Access Compliance Report

Public Rights-of-Way

(Curb Ramps)

Intersection ID: 14272	Main Street: BROOKHILL_RD	Cross Street: VILLAGE_CT	Location: SW
ADA ID: 24E0D5B775EC	Ramp Type: PerpDiag	Initial Pass/Fail: Fail	Overall Compliance: No
Codes/Mitigation Info/Possible Solution		Field Measurements/Component Compliance	
Severity Score: 13.75

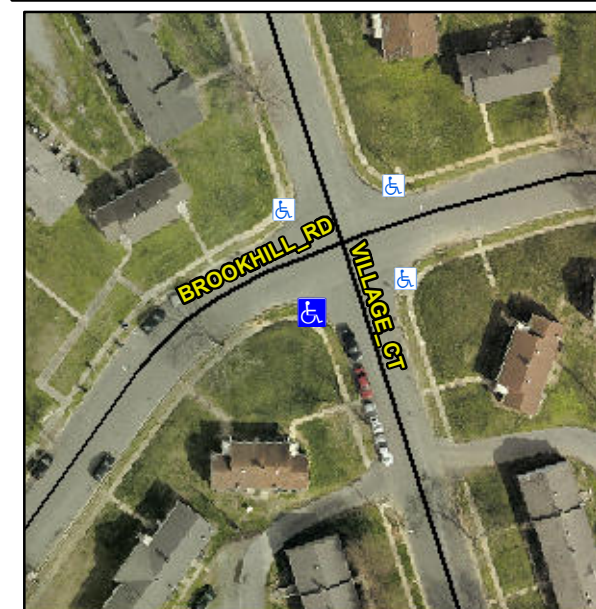
PROW/ADA:

Not Found, R304.2.2, R304.5.3

Compliance	Description	Data	Compliance	Description	Data
N/A	Ramp Length (in)	43.0	No	Ramp Slope (%)	11.1
Yes	Ramp Width (in)	48.0	No	Ramp XSlope (%)	3.2
N/A	Flare Type LT	N/A	N/A	Flare Type RT	N/A
N/A	Flare Slope LT (%)	N/A	N/A	Flare Slope RT (%)	N/A
N/A	Flare Traversable LT?	N/A	N/A	Flare Traversable RT?	N/A
N/A	Landing Length (in)	N/A	N/A	DWS Provided?	N/A
N/A	Landing Width (in)	N/A	N/A	DWS Contrast?	N/A
N/A	Landing Slope (%)	N/A	N/A	DWS Length (in)	N/A
N/A	Landing X Slope (%)	N/A	N/A	DWS Full Width?	N/A
N/A	Landing Curb? (Y/N)	N/A	N/A	DWS Offset (in)	N/A
N/A	Shared Landing?	N/A			
N/A	Gutter Ponding?	N/A	N/A	Gutter Slope (%)	N/A
N/A	Gutter Lip Ht (in)	N/A	N/A	Gutter X Slope (%)	N/A
N/A	Painted X Walk1?	No	N/A	Painted X Walk2?	No
	X Walk 1 Direction	To E		X Walk 2 Direction	To N
N/A	X Walk 1 Width (in)	N/A	N/A	X Walk 2 Width (in)	N/A
	X Walk 1 Slope (%)	3.7		X Walk 2 Slope (%)	0.2
	X Walk 1 X Slope (%)	1.8		X Walk 2 X Slope (%)	2.6

Remove & Replace Curb Ramp With Two New Directional Ramps or Equivalent.
